Project Number: 2024-055

**RE: Geotechnical Services for Construction Phase of Retaining Wall Replacement
Prospect Heights, Canmore, AB**

As requested by ISL Engineering and Land Services (ISL), Taylor Geotechnical Ltd. (TGL) has conducted a review of the construction phase associated with the retaining wall replacement project at Prospect Heights in Canmore, AB (hereafter referred to as the “site”). The purpose of the review was to provide comments and recommendations pertaining to the construction phase of the retaining wall replacement project.

TITLE: Construction Case at Sta 30+024

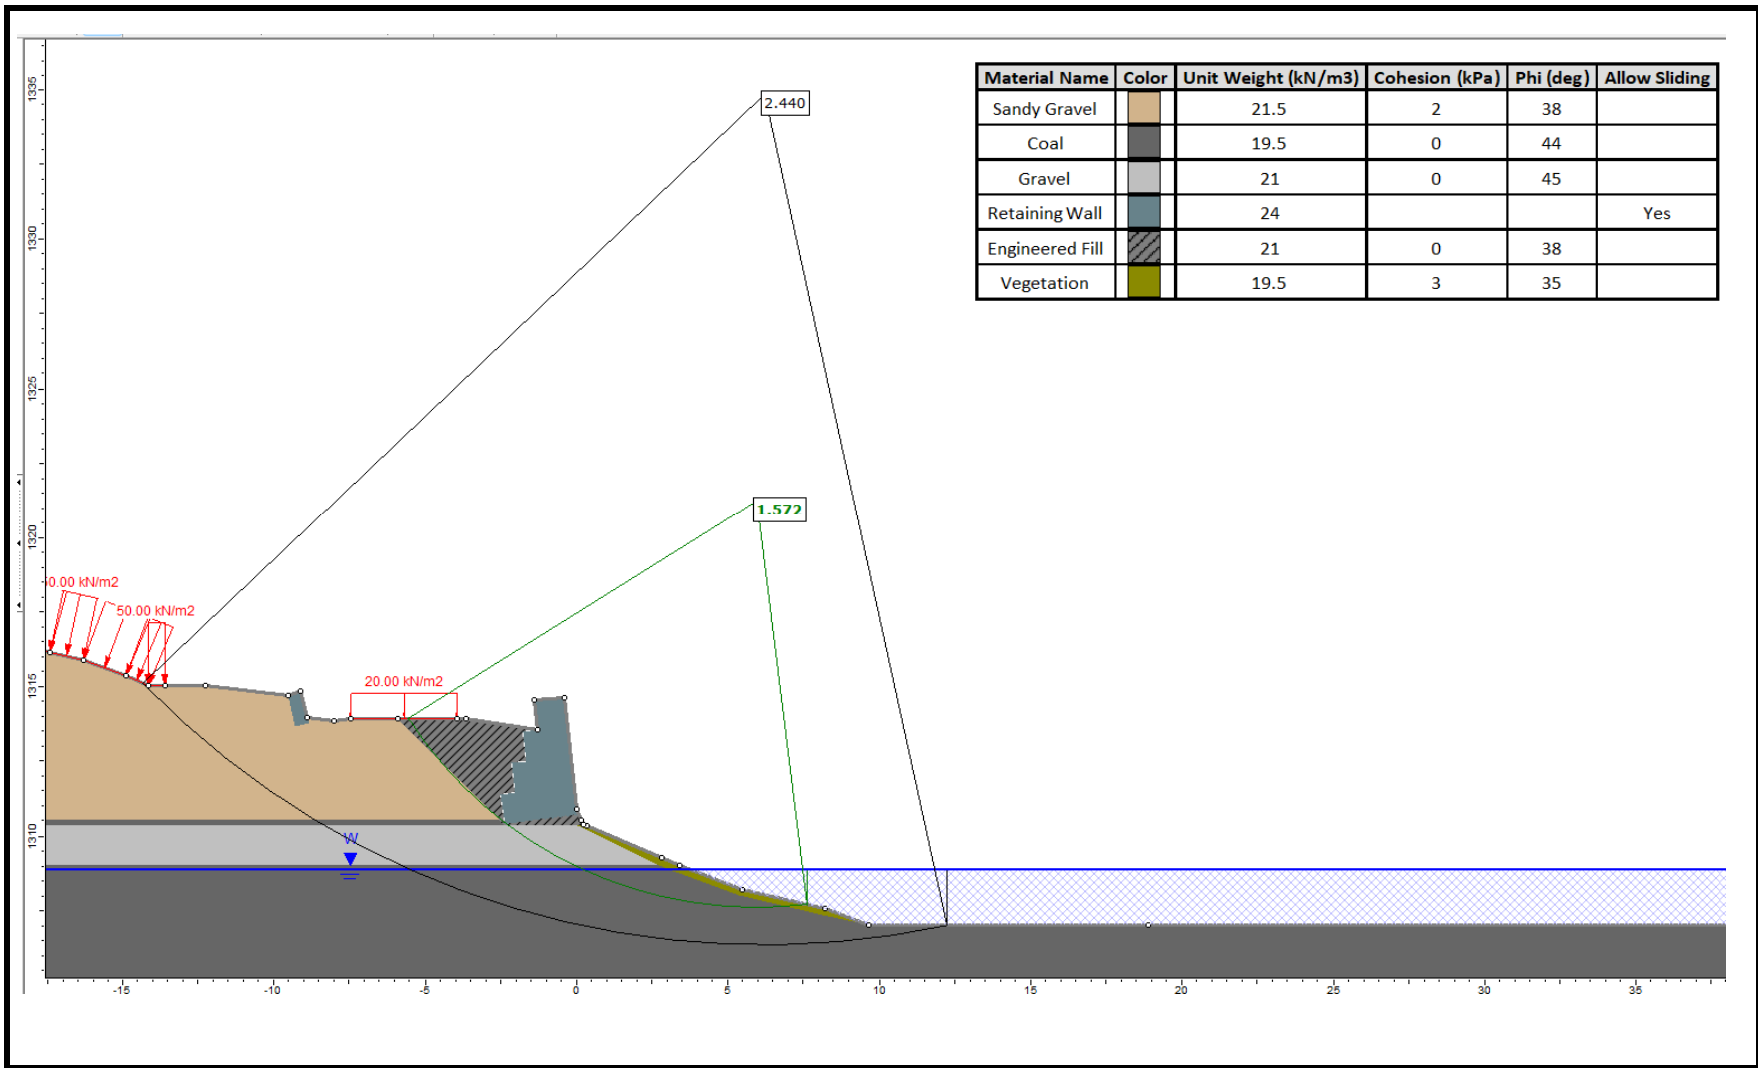
Section 3, located at Station 30+024, was deemed the critical section for the construction case as the retaining wall is tallest in this location. It is understood that a construction cut of 1 horizontal to 1 vertical (1H:1V) is to be used, which was assessed in this analysis. It was assumed that the overlying pathway will remain closed throughout the duration of construction and therefore no loading was considered at the pathway location.

Section	Local FOS	Global FOS
3 (Sta 30+024)	1.16	2.35

Based on the slope stability analysis, a construction cut slope of 1H:1V is considered stable in terms of short-term performance and is therefore appropriate for construction. The cut slope does not influence the overall global stability of the slope, and the overlying infrastructure, inclusive of the condominium, is unaffected.

- A construction cut slope of 1H:1V is permitted. The pathway should remain closed throughout the duration of construction.
 - If steeper temporary excavation side slopes are required, additional geotechnical review is required.
 - Should sloughing soils or shallow groundwater be encountered during construction, excavations will need to be flattened. Additional geotechnical review is required to provide specific input on these requirements.
 - If excavations extend below the groundwater table, dewatering should be in place immediately after excavation. Dewatering should work continuously while constructing below the groundwater level. Dewatering is typically the responsibility of the contractor.

Reference: Slide2	DATE:	2024-05-24	 TAYLOR GEOTECHNICAL	PROJECT: Prospect Heights Retaining Wall Global Stability Analysis		
	DRAWN:	RM		TITLE: Design Case at Sta 30+024		
	DESIGNED:	RM		PROJECT #: 2024-055		
	CHECKED:	HT		FIGURE:	A2	REV.: 0
	APPROVED:	HT	CLIENT:	ISL

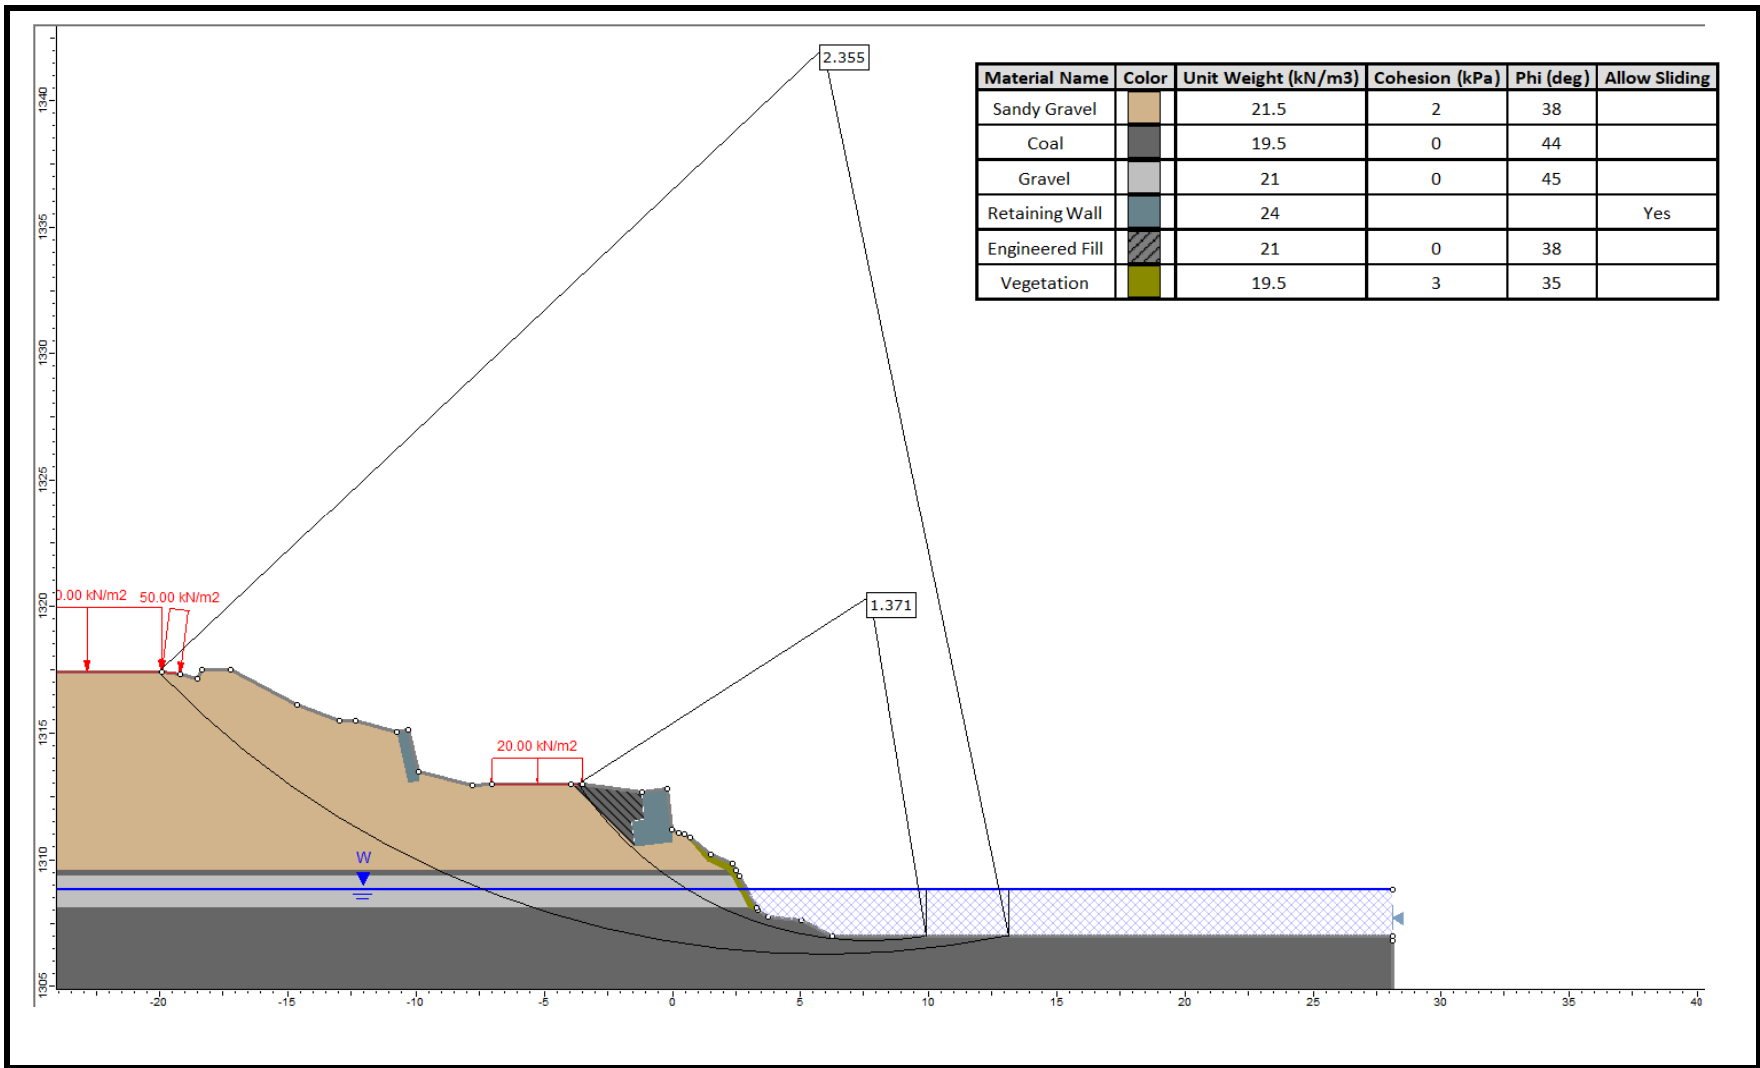
Section	Local FOS	Global FOS
3 (Sta 30+024)	1.57	2.44
1 (Sta 30+005)	1.37	2.35

Based on the slope stability analysis, the retaining wall at Station 30+024 is stable in terms of long-term performance. Additionally, the entire slope remains stable in terms of global stability at both section locations. However, the local FOS at Station 30+005 does not meet the minimum FOS criteria, with a FOS less than 1.5.

- The proposed retaining wall design located at Station 30+024 is considered acceptable in terms of local global stability.
- The proposed retaining wall design located at Station 30+005 does not meet the FOS criteria, with local global FOS less than 1.5. It is anticipated that the low FOS in this area can be attributed to the over-steepened slope located beneath the retaining wall.
- TGL recommends adjusting the retaining wall design at Station 30+005 to allow for greater embedment.
 - A revised design should consider a deeper embedment vertically into the ground surface, and/or horizontally into the sloping terrain.
 - An additional slope stability analysis should be undertaken to determine the revised design. TGL can complete this upon request.
